MEMORANDUM

DATE *revised* April 10, 2013

PROJECT Riverside Main Library
SOIS Review

REGARDING: RIVERSIDE LIBRARY SECRETARY OF THE INTERIOR'S
REHABILITATION STANDARDS REVIEW

Sketch 1

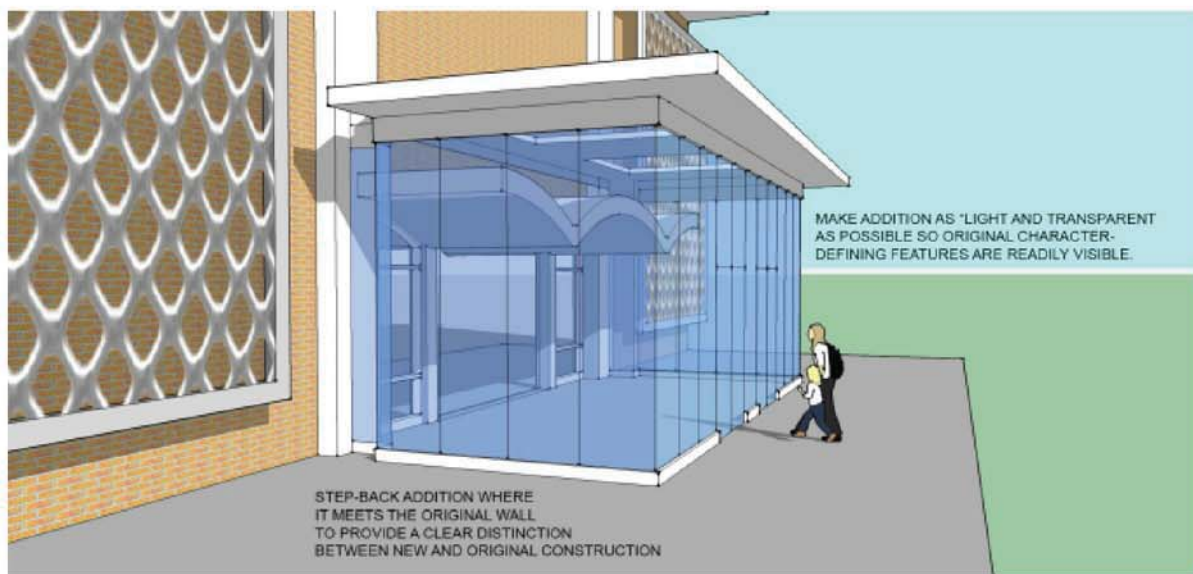
2. Step-back the sidewalls and roof projection of the new entry addition at the connection to the original wall plane to provide a clear differentiation between new and original construction. [Refer to Sketch 1].

3. Traditionally, changes to the main entrances are viewed unfavorably through the lens of the *Secretary's Standards*. In order to conform, the character-defining sculptural concrete entry canopy and associated pendant globe lights must remain highly visible from the plaza. Therefore, the proposed entrance bay addition should be designed as light and transparent as possible. The roof line of the addition should be visually subordinate to the features of the entrance. The use of generous, relatively uninterrupted (frameless) expanses of glazing could decrease visual impacts to character-defining features and further differentiate the removable addition. [Refer to Sketch 1].

The design should not obscure the visibility of the sculptural entrance canopy. In addition, an effort should be made to provide skylights or laylights that will allow for natural illumination, thereby increasing visibility of the original entrance.

OPTION 5b ELEVATION
SCALE 1/16" = 1'-0"

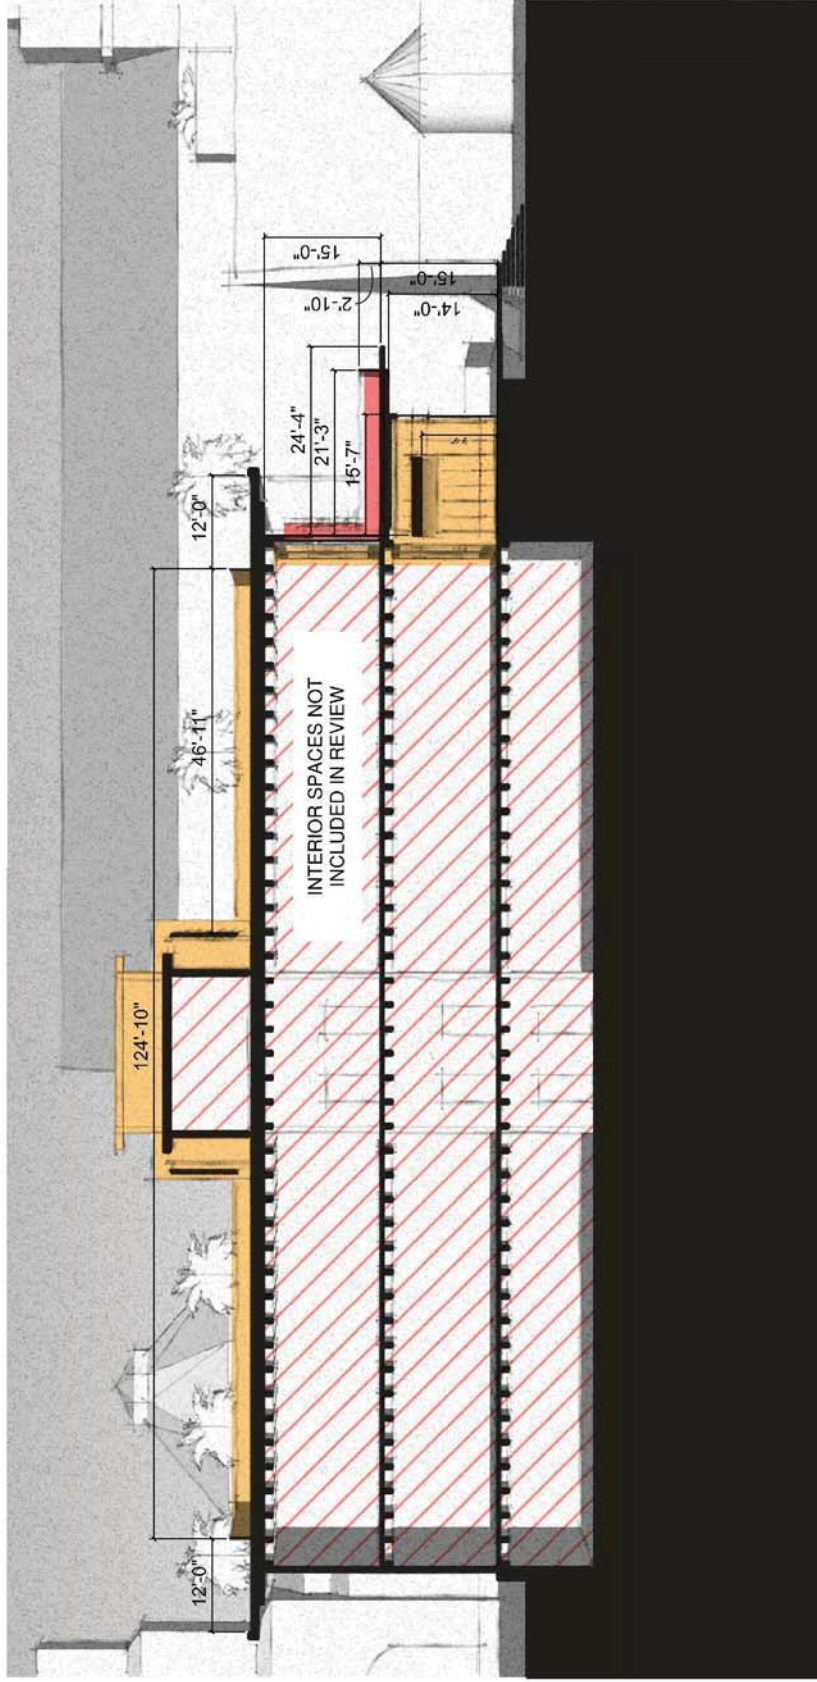
1. The **proposed exterior doors for from the second floor to the deck above the addition need to be eliminated from the project** in order to conform with the *Secretary's Standards* Nos. 1, 2, and 9 (see above). The addition of upper-façade doors would represent more than a "minimal change" to distinctive materials (smooth/planar brick wall surfaces) and features (the façade's overall design configuration). The addition of upper-façade doors and a thickened profile for the proposed entrance bay through the addition of a roof deck and railing will alter the building's principal character-defining feature, the distinctive entrance design and materials. These changes constitute **more than a "minimal change" to the distinctive features and spatial relationships of the building**.

4. The proposed addition of windows behind the full-height lattice-work screens could conform with the *Secretary's Standards* if their size, configuration, and design do not detract from the appearance and design of the screens. Window openings should be held back from the edges of the screens.

5. As indicated, the proposed railing on the main roof-deck addition should be set back. In order to minimize visual impacts to the building's character-defining massing and form, the railing height should be as low as possible (while still in conformance with building code requirements).
6. Proposed skylights on the roof would conform to the *Secretary's Standards* if they are not visible from the ground level.
